ZONING COMMITTEE STAFF REPORT

FILE # 15 011695

- A. **PURPOSE:** Site plan review for a 4-story mixed-use building fronting on S. Cleveland Ave. between Highland Parkway and Pinehurst Ave.

SITE PLAN
 1" = 30'-0"

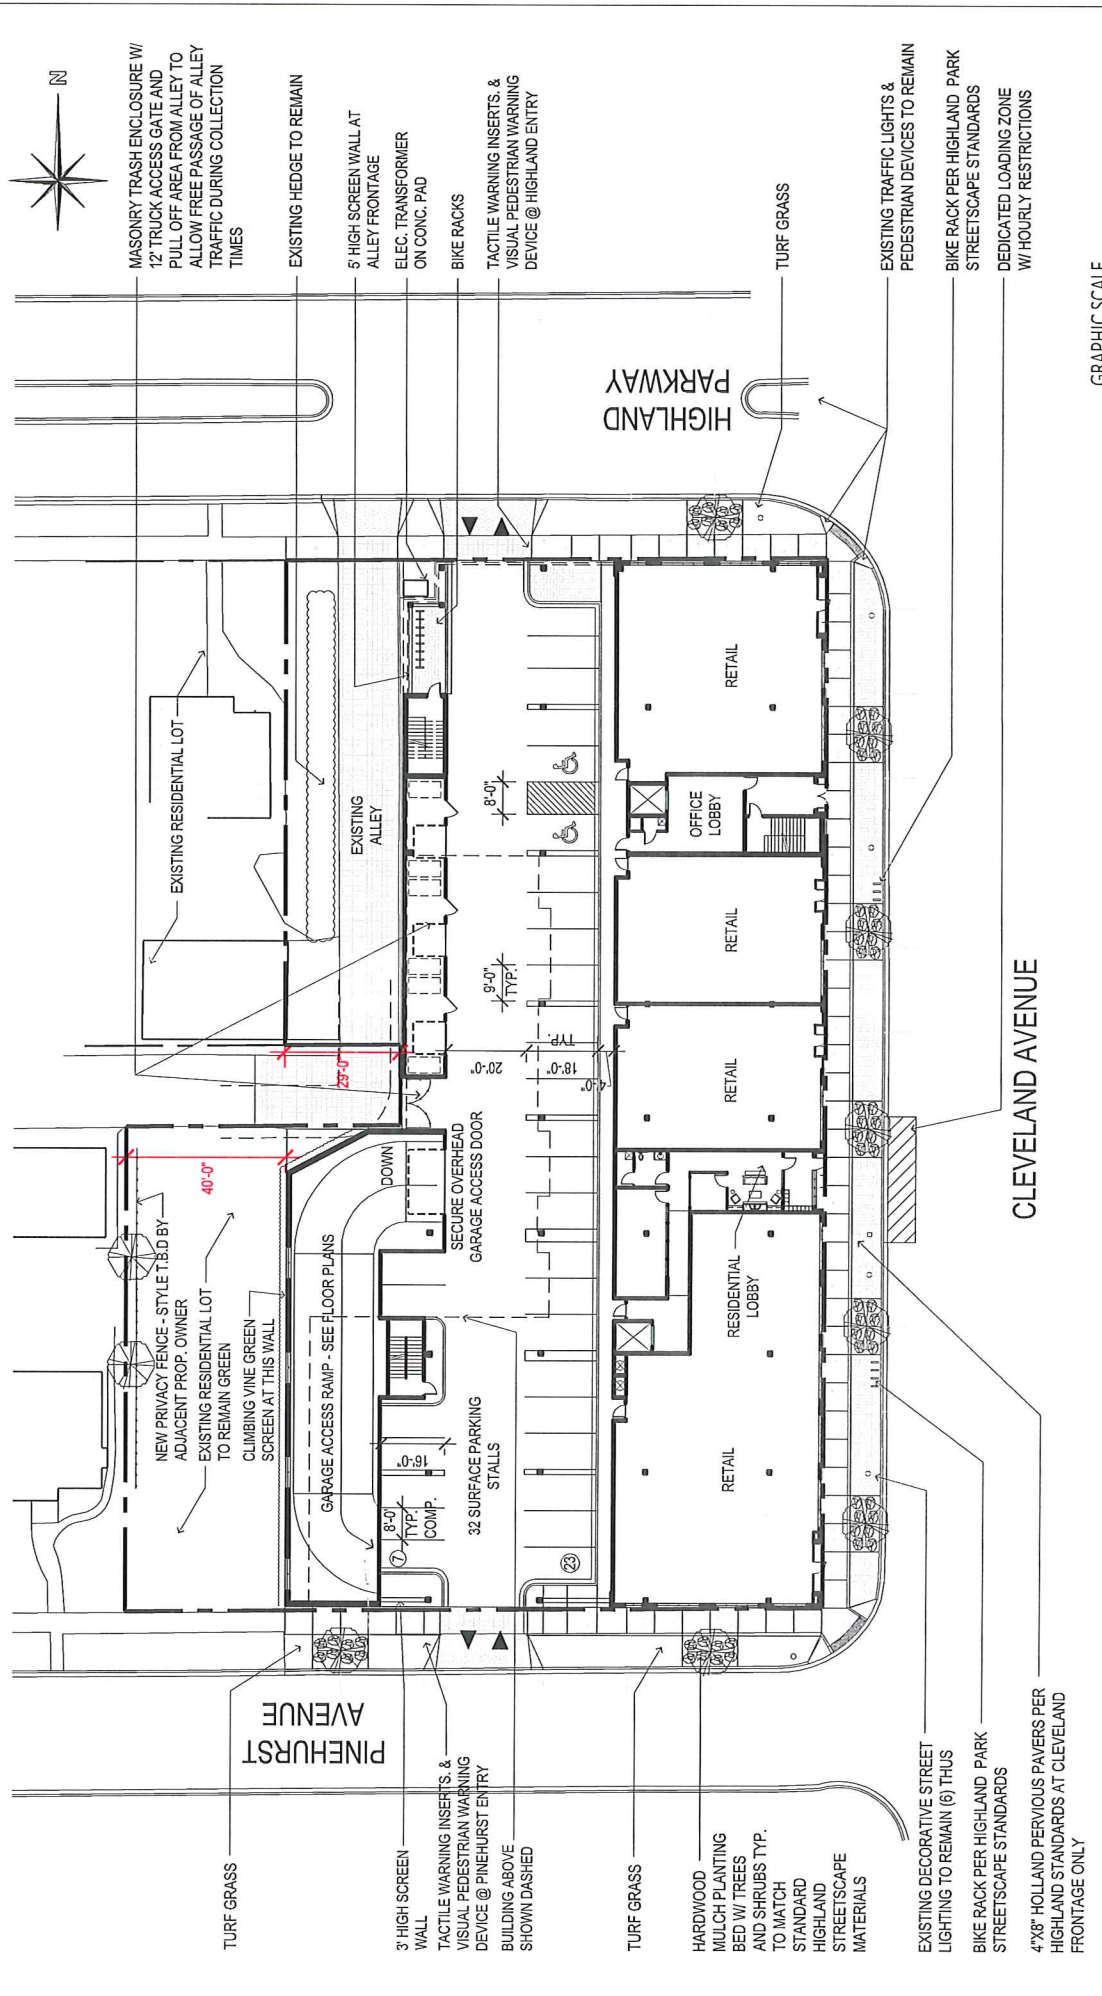
3. The plans must show the requirements of the City Forester, i.e., to put a note on the "Removals Plan" to get a tree permit before removing existing boulevard trees and to show on the site and landscape plans that 4 new trees will be planted on Pinehurst to replace the 4 that are being removed (only 2 are currently shown).

WEST ELEVATIONS
 SCALE: 1" = 20'-0"

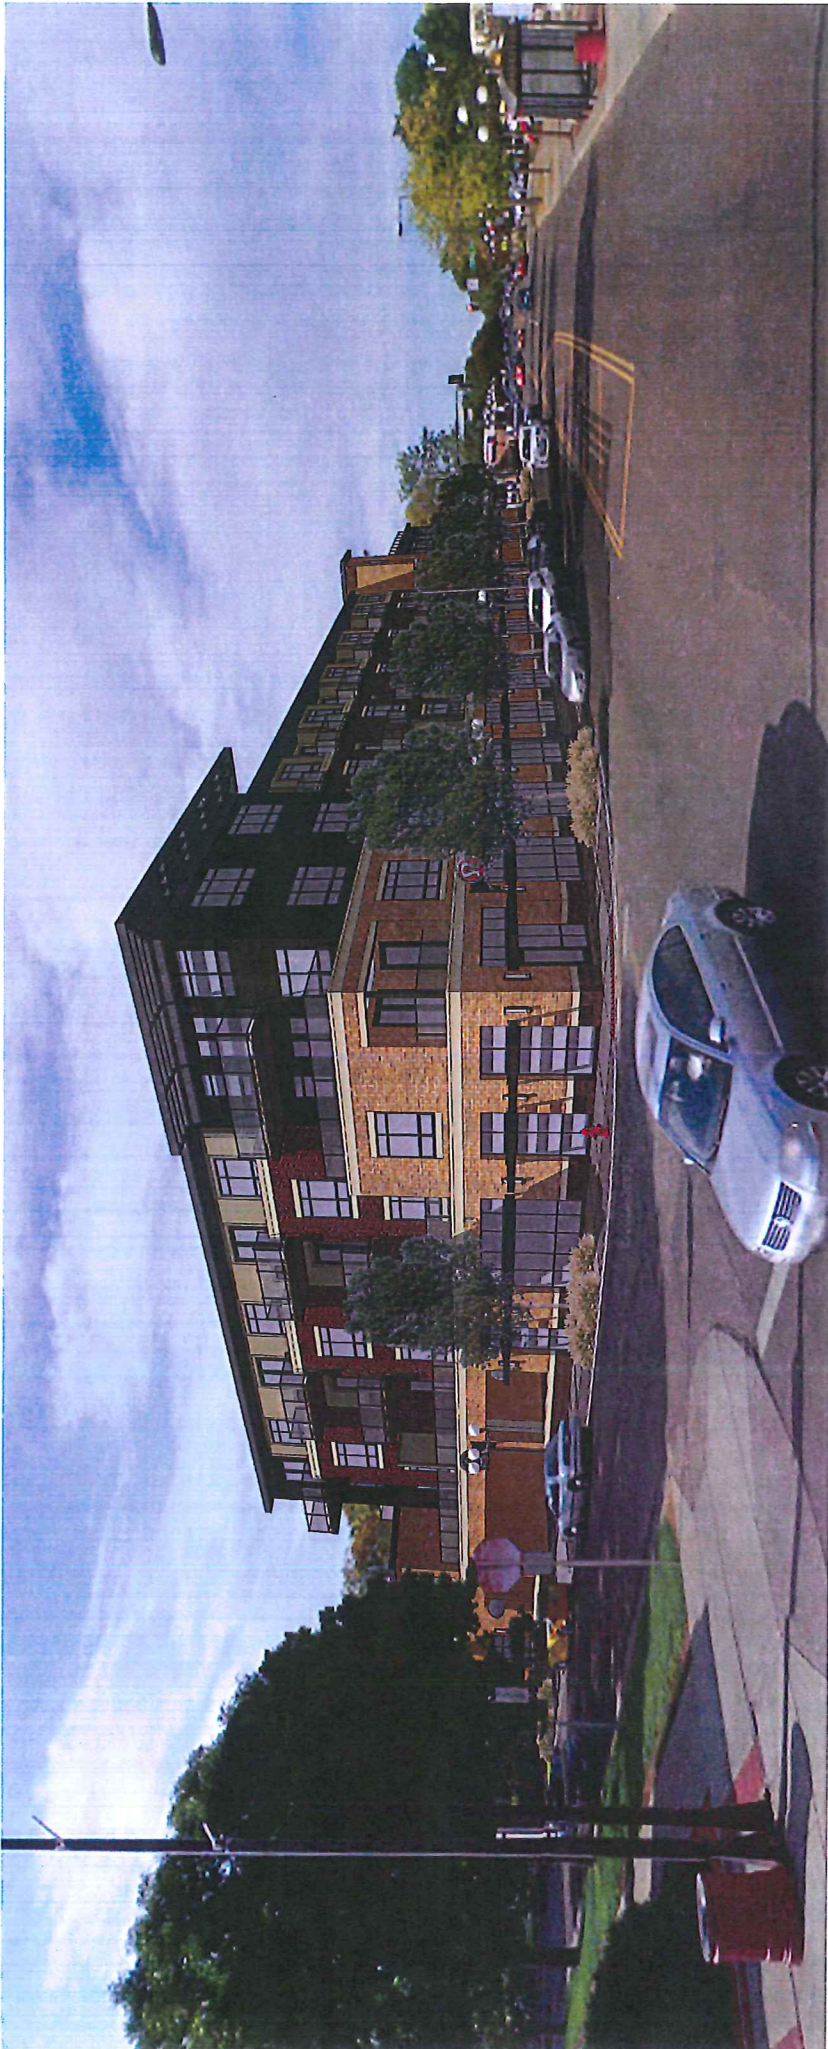
Alley Facade → (Will change door for garbage truck)
